## POLICY REPORT DEVELOPMENT AND BUILDING

Report Date: December 1, 2009  
Contact: Nicky Hood  
Contact No.: 604.873.7699  
RTS No.: 08323  
VanRIMS No.: 08-2000-20  
Meeting Date: December 15, 2009

TO: Vancouver City Council  
FROM: Director of Planning  
SUBJECT: CD-1 Rezoning - 6708-6776 Granville Street

BUILDING 1 (3 SIMILAR)  
WEST ELEVATION  
(GRANVILLE STREET)  
BUILDINGS 1-4  
BUILDING 2 (4 SIMILAR)

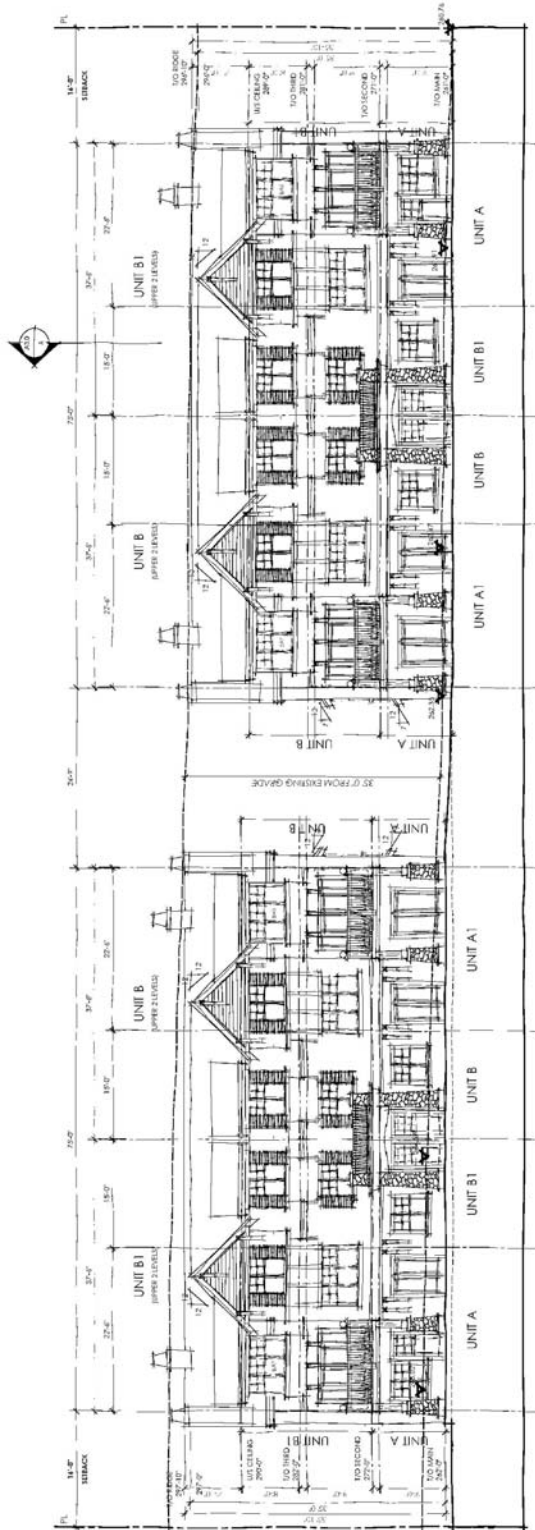
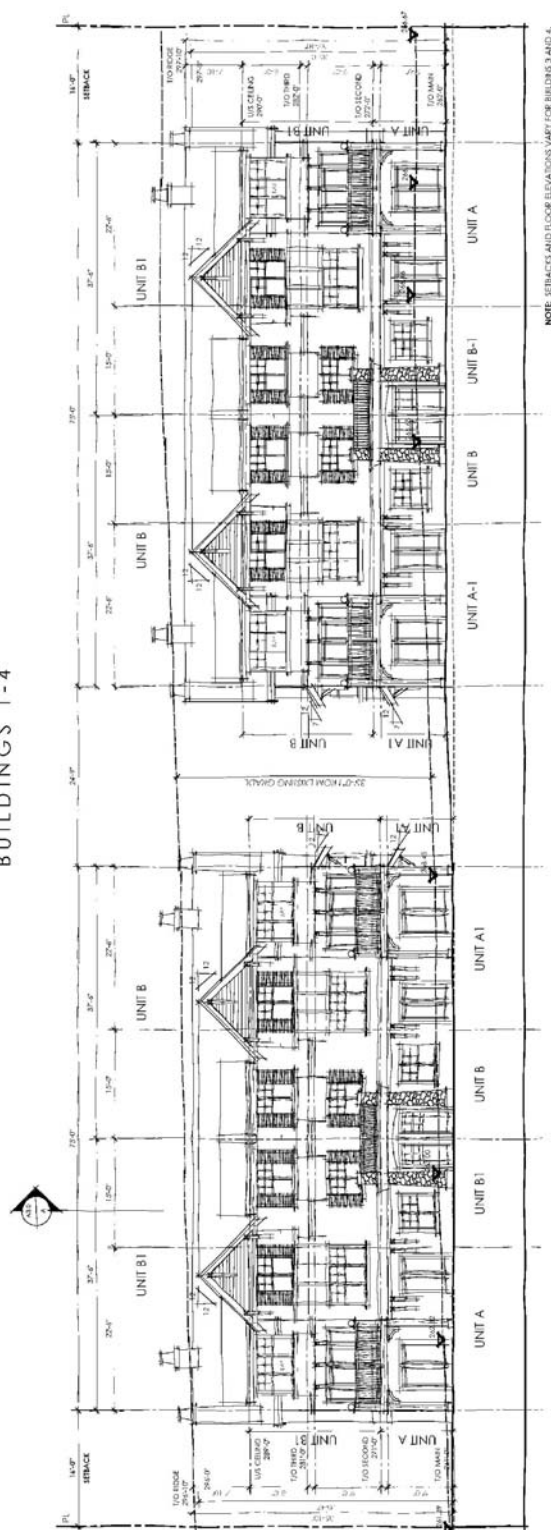
- (i) Design development to the building expression to achieve variety;

Note to Applicant: The styles of the different buildings should be varied to allow each building individual identity. This should be executed so that the variations are integral to the building forms. The group of buildings should maintain a strong connection in their form and detailing.

- (iii) Provision of high quality building materials appropriate to the use;

Note to Applicant: The building materials noted in the project description including, heavily textured stucco, robust wood detailing, quarried stone and asphalt shingles must be noted and located on elevation drawings.
